# UNITED STATES PATENT AND TRADEMARK OFFICE

APPLICATION NO.	FILING DATE	FIRST NAMED INVENTOR	ATTORNEY DOCKET NO.	CONFIRMATION NO.
09/966,427	09/28/2001	Harini V. Sundaresan	TI-31767	6354
23494	7590	03/09/2005	EXAMINER	
TEXAS INSTRUMENTS INCORPORATED			TORRES, JUAN A	
P O BOX 655474, M/S 3999			ART UNIT	
DALLAS, TX 75265			PAPER NUMBER	
			2631

**Office Action Summary**

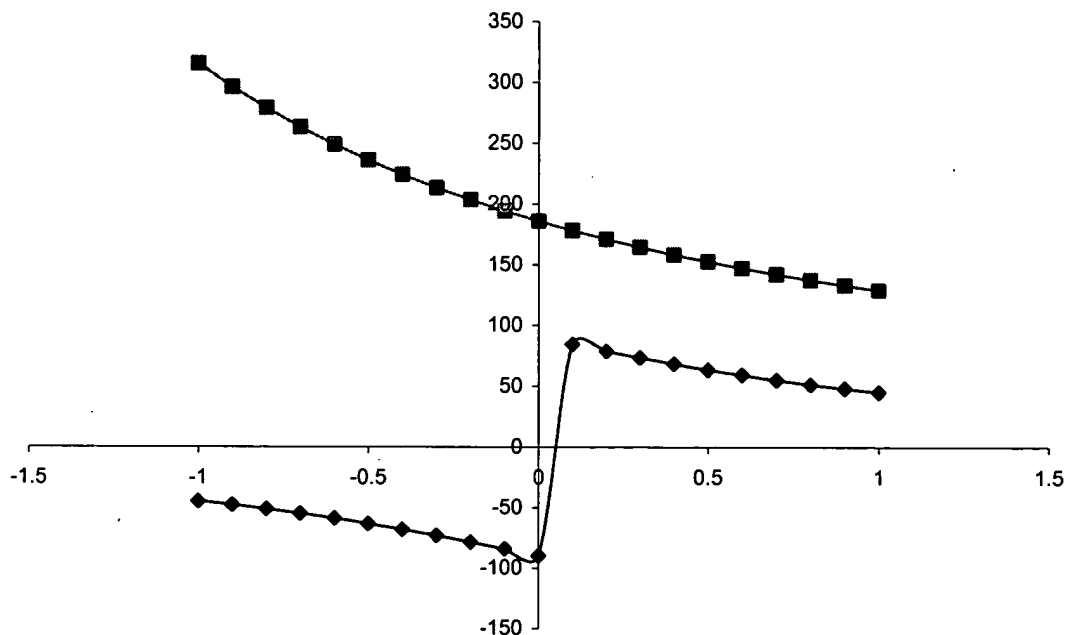
Claims 1-10 rejected under 35 U.S.C. 101 because the disclosed invention is inoperative and therefore lacks utility. The disclosure present a method for computing the value of arctangent ( $IM/RL$ ) and  $7 \times \arctangent (IM/(RL+2))$  in all the values of IM in  $[-1, 1]$ , and RL in  $[-1, 1]$ . The following graphic is a representation of the two values of arctangent ( $IM/RL$ ) and  $7 \times \arctangent (IM/(RL+2))$  (in the OY axes) for the case where  $IM=1$  and RL from  $-1$  to  $1$  (in OX axes):

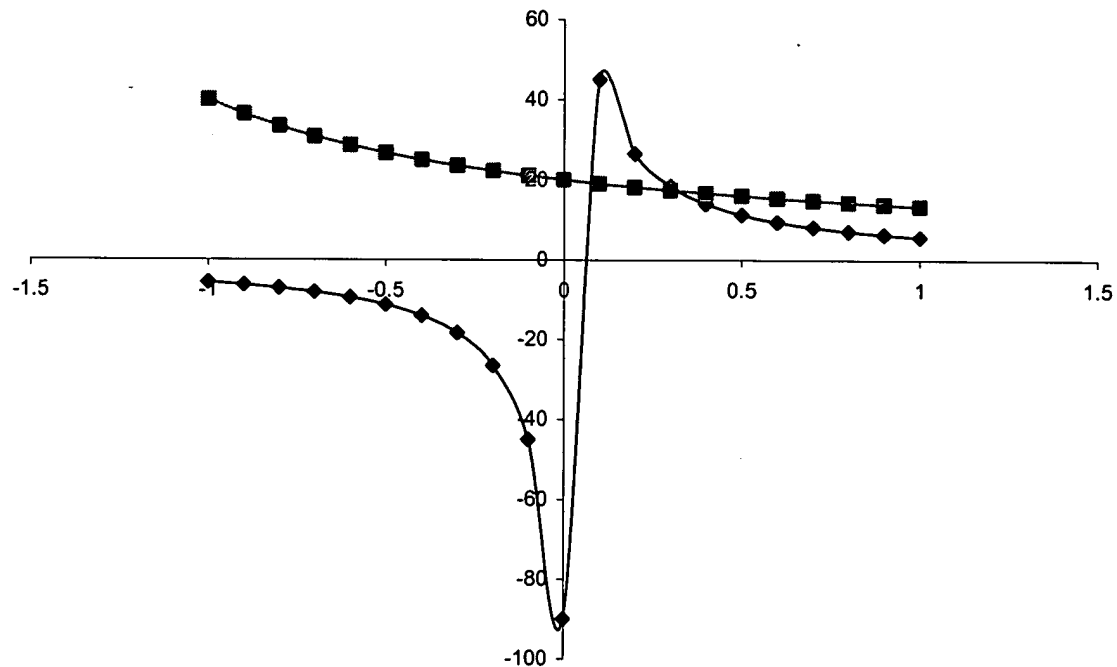
It can be seen that this approach proposed is not valid in any range of values. The same representation for a value of  $IM=0.1$  is:

It is evident that the approach is not good at all. The proposed claims lack of utility in the full range of the disclosure.

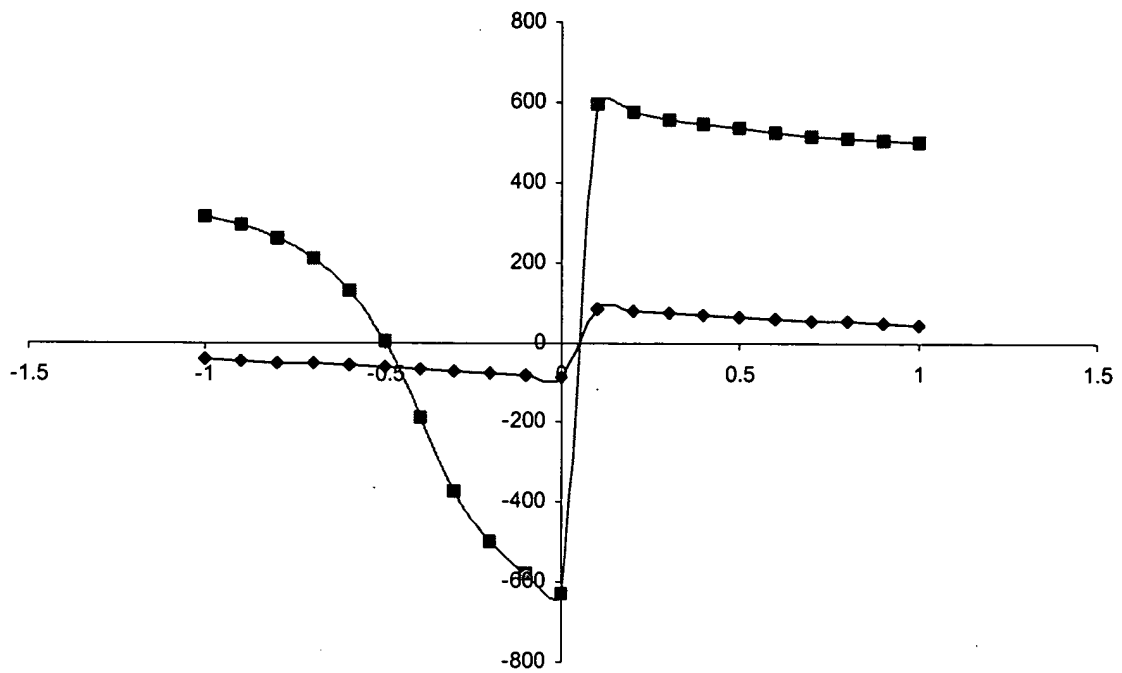
In the case that the application means the value of  $((IM/RL) + 2)$  instead of  $(IM/(RL+2))$  the approach will also not be true (this case will not be supported by the disclosure). In the case  $((IM/RL) + 2)$  for low values of  $RL$  the number 2 is depreciable compare with  $(IM/RL)$  and in those cases  $(RL \ll 1)$  the approach will be possible, but with no gain in burden complexity because still the value  $(IM/RL)$  have to be computed for  $RL$  close to zero. This situation can be shown in the following graphic for the case  $IM=1$ .

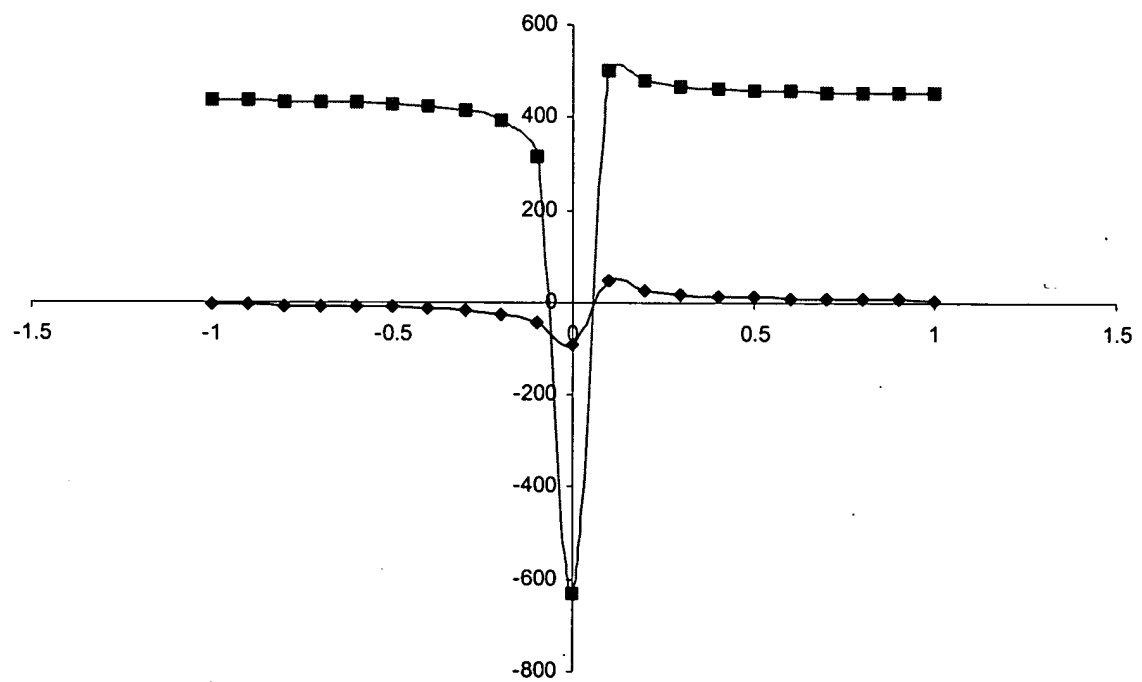
In the case of  $IM=0.1$  the representation will be:
